Job No: 2011-09-2334-ALTCOMM	Date Applied: 9/28/2011	CBL: 048- F-005-001	
Location of Construction: 80 SHERMAN ST	Owner Name: ROMAN CATHOLIC DIOSESE	Owner Address: 510 OCEAN AVE PORTLAND, ME 04103	Phone: 773-7746
Business Name: Sacred Heart Parish – Denis Lafremier	Contractor Name: Twin Oak Construction	Contractor Address: Boulder Ridge, Hollis Center, ME 04042	Phone: 838-7771
Lessee/Buyer's Name:	Phone:	Permit Type: Parking Lot expansion	Zone: R-6
Past Use: Sacred Heart Rectory – Church offices & offices for Catholic Charities of Maine & Refugee Resettlement Program & Interpretive Program	Proposed Use: Same Use – to expand the existing parking lot by 2,240 sq ft	Cost of Work: \$26,000.00	CEO District:
		Fire Dept: <input type="checkbox"/> Approved <input type="checkbox"/> Denied <input checked="" type="checkbox"/> N/A	Inspection: Use Group: Type: N/A Signature: 
Proposed Project Description: expansion of existing parking lot		Pedestrian Activities District (P.A.D.)

Project Name:	EXPANSION OF PARKING LOT	Project ID:	2011-279
Project Address:	80 SHERMAN STREET	CBL:	048-F-005
Applicant:	ROMAN CATHOLIC BISHOP OF PORTLAND		
Planner:	SHUKRIA WIAR

PROJECT DESCRIPTION:
ADD 2,855 SF OF P

REV.	DATE	DESCRIPTION
ROMAN CATHOLIC BISHOP OF PORTLAND PO BOX 11559, PORTLAND ME 04104 SACRED HEART PORTLAND, MAINE		
CONSULTING ENGINEER FUMOUR, MAINE SITE PLAN		
SCALE: AS SHOWN	DRN BY: RJS	C1.2
DATE: JUNE 7, 2011	DESG BY: JTR	
PROJECT: 10144	CHK BY: JR

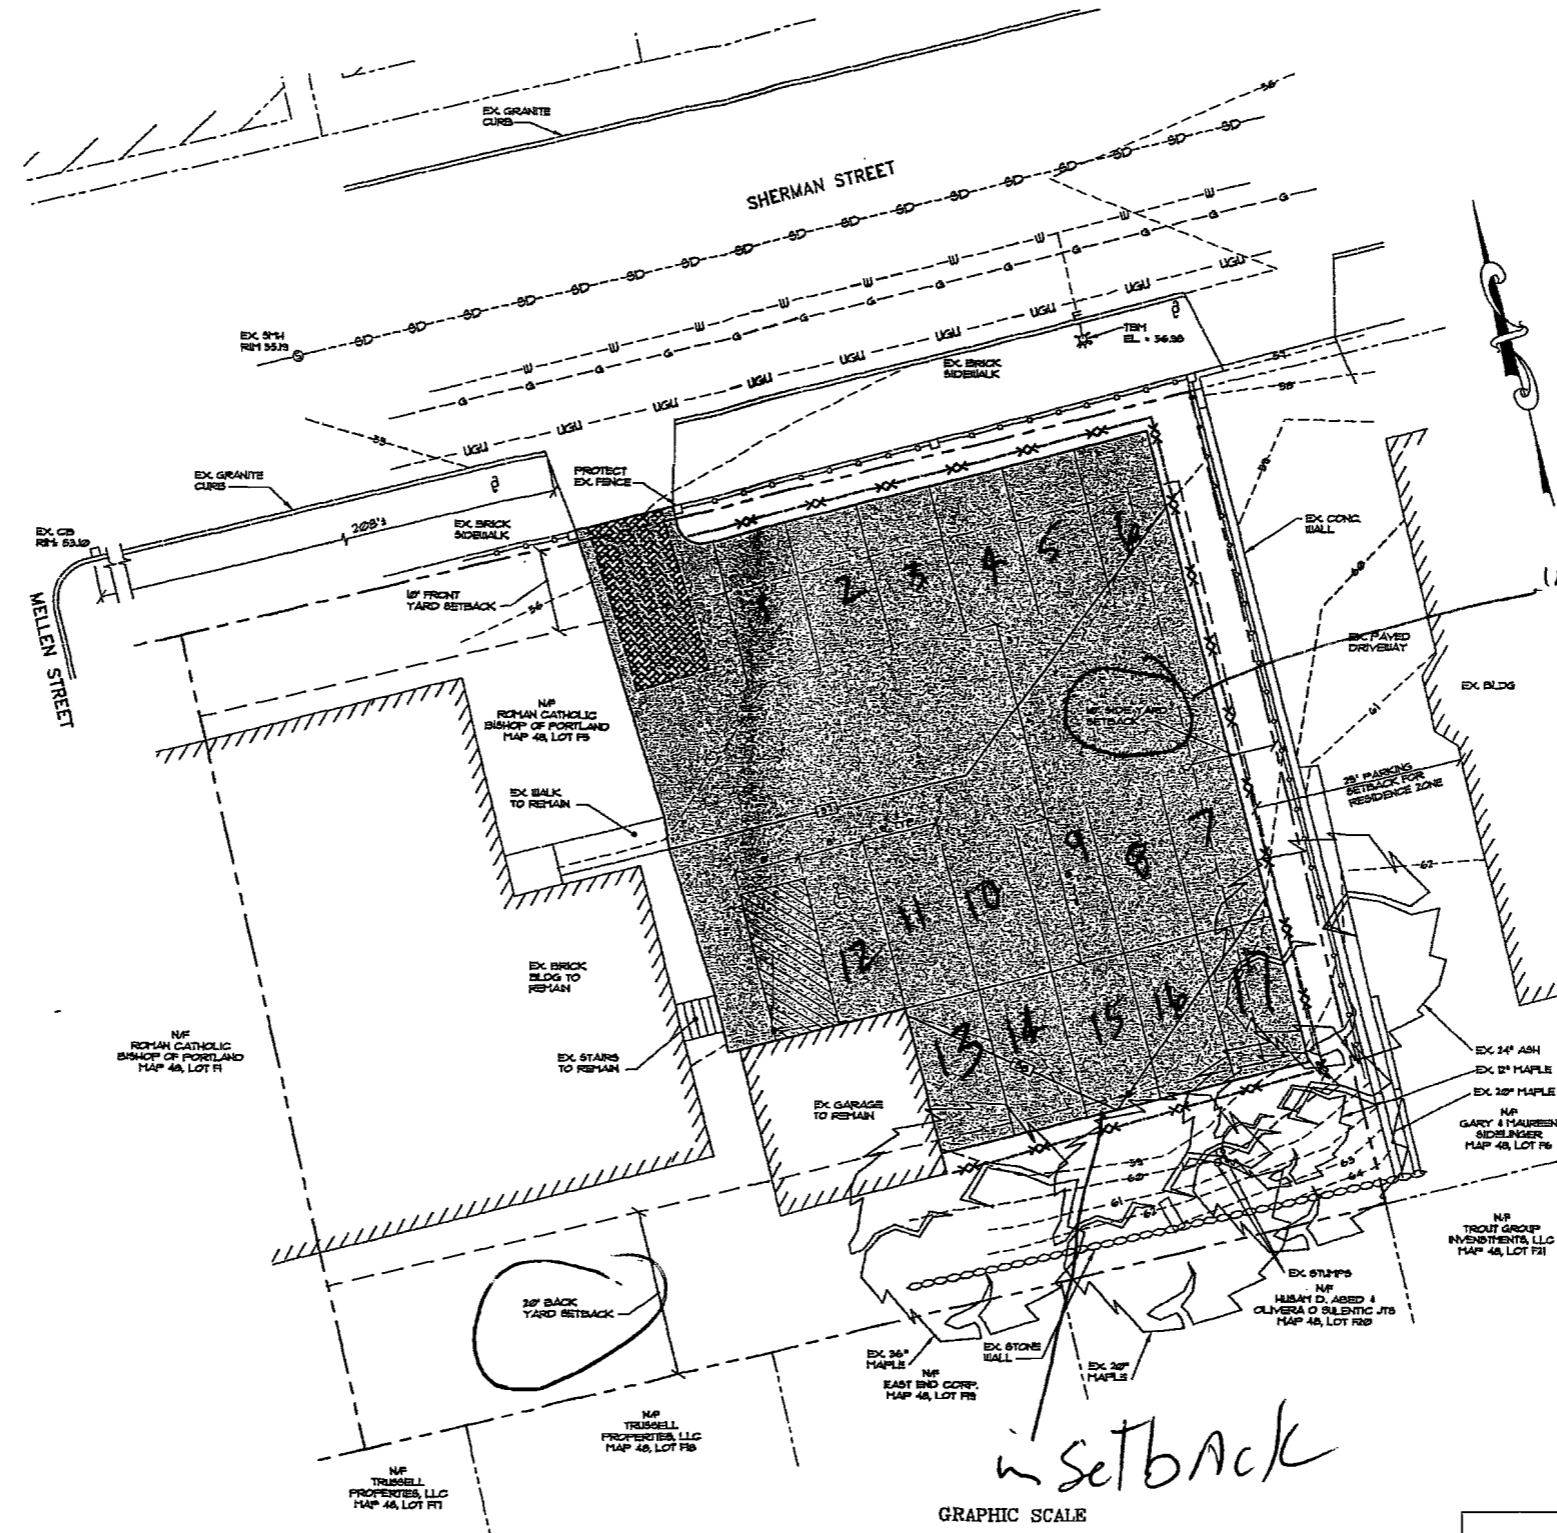
- b. That the applicant shall modify the contours on the site plan to grade the stormwater drainage towards the vegetated strip along Sherman Street. This vegetated strip shall be depressed three inches below grade level of the adjacent parking lot.

3. We have corrected the scale notation on Sheet C1.2 and added curb stops to the proposed construction. An updated plan sheet is attached for your review. We hope you find our request for a waiver of bicycle parking favorable.

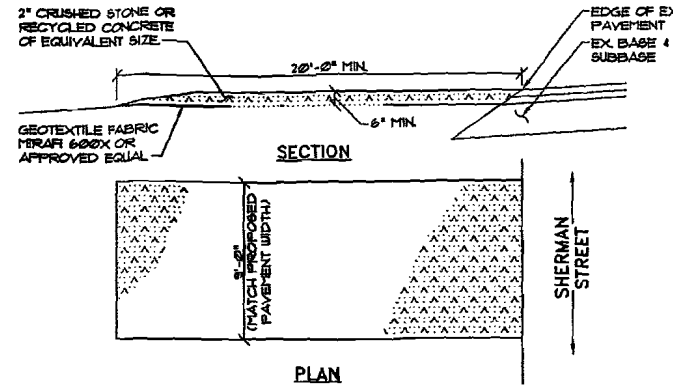
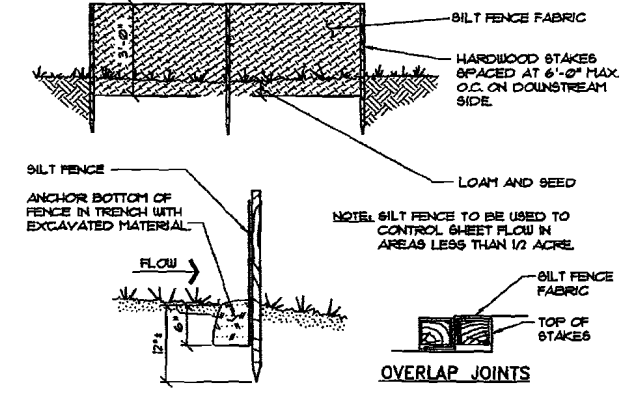
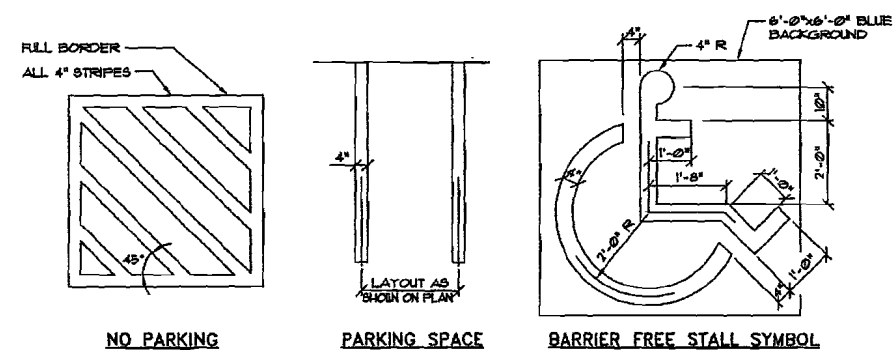
Apparently I missed the curb detail shown on C1.3. Thank you for pointing out the detail. It is meeting the requirements of the Ordinance.

plan Cl. 3 does show 6" wheel stops

This proposal is to expand an existing accessory parking lot from 6 parking spaces to 17 parking spaces. The property is located in an R-6 zone with a Historic Overlay. The new parking is shown within the required rear and side setbacks. Section 14-338 requires continuous curb guards, rectangular in cross-section, at least six (6) inches in height. I am not seeing that the provided detail on C1.3.

Detail Sheet C1.3 to include a tree protection detail for existing trees adjacent to the work area. The proposed parking area was designed to minimally impact established vegetation on the property by tying into existing surface contours at the edge of pavement to minimize site grading beyond the limits of the parking surface.
